## UI BULLETIN # 90b

**SUBJECT:** Chassis Cab Fuel Filler Assembly `Service Body`  
Installation Guide

**MODELS AFFECTED:** Chevrolet Silverado, GMC Sierra ALL  
With RPO ZW9 or Pick Up Box Removal

**Diesel Version:**

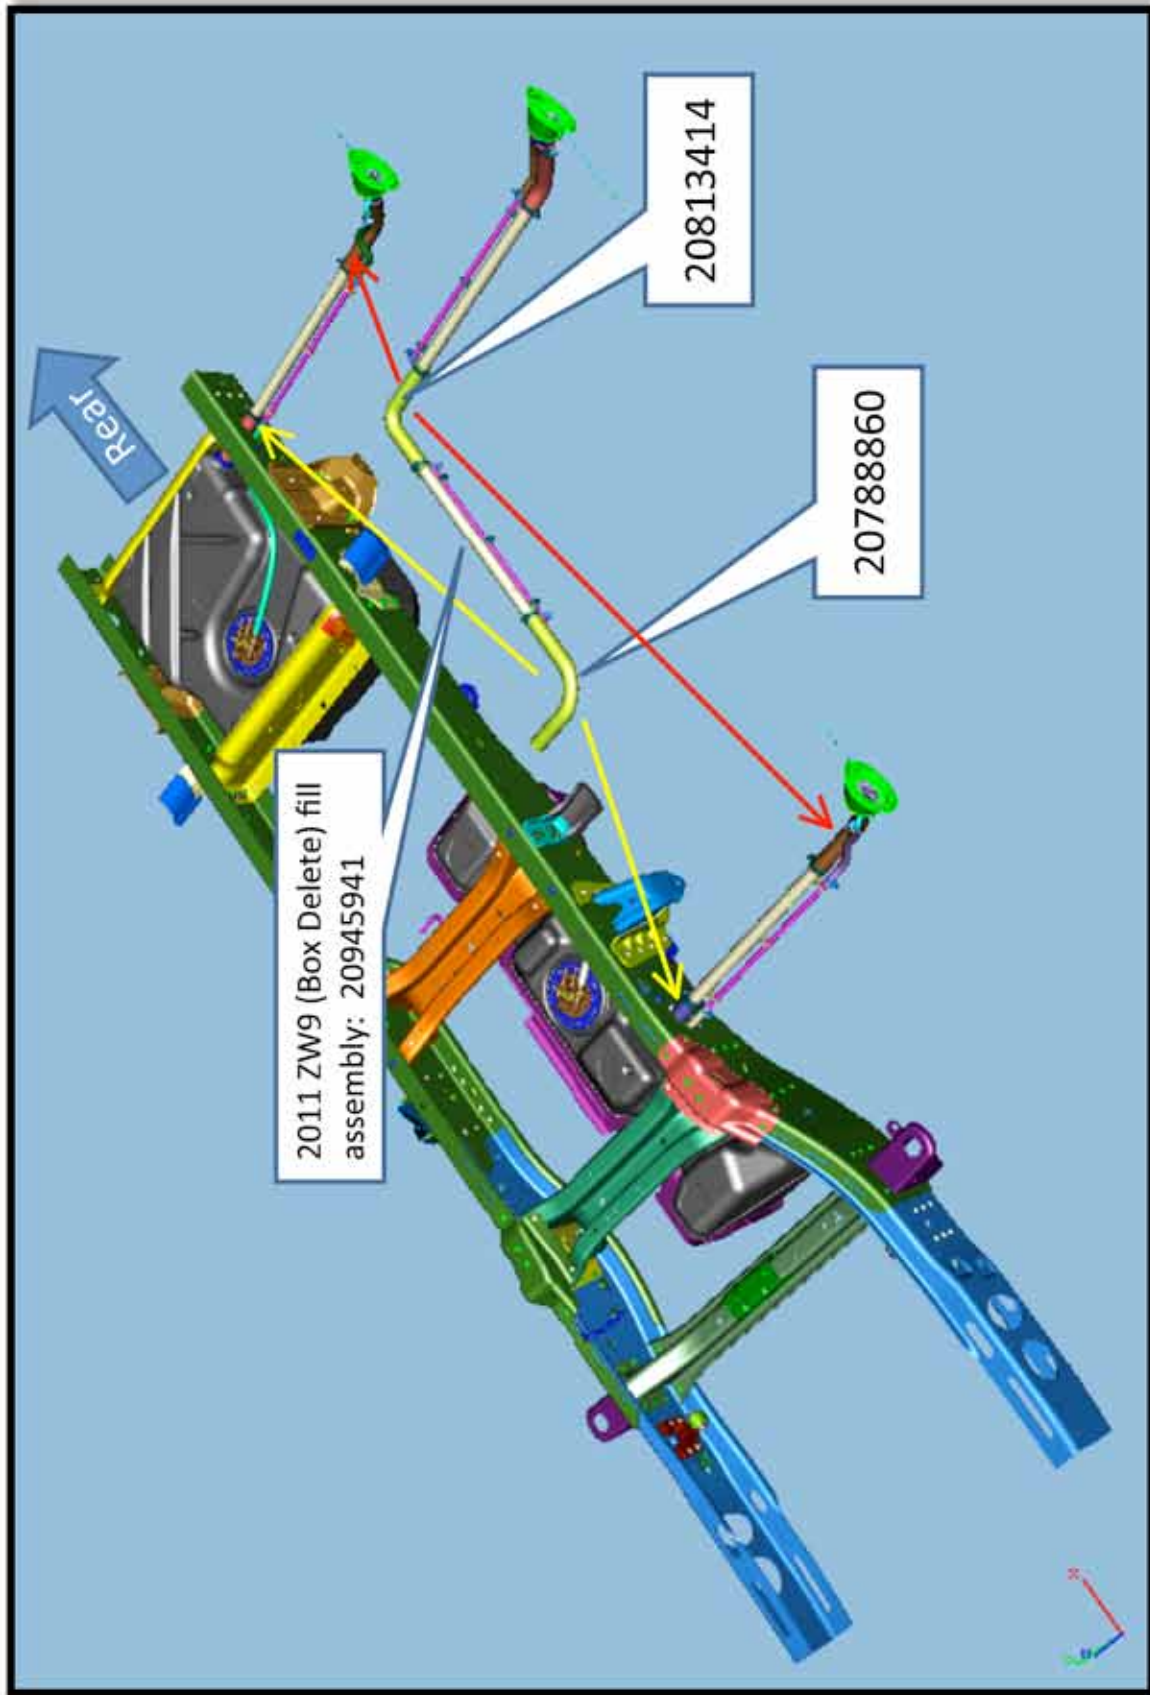
- Replace lower fill hose with (20788860) (see page 2)
- Replace upper fill hose with (20813414) (see page 2)
- Trim as necessary
- Maintain clamp torque (4 +/- .5 Nm)
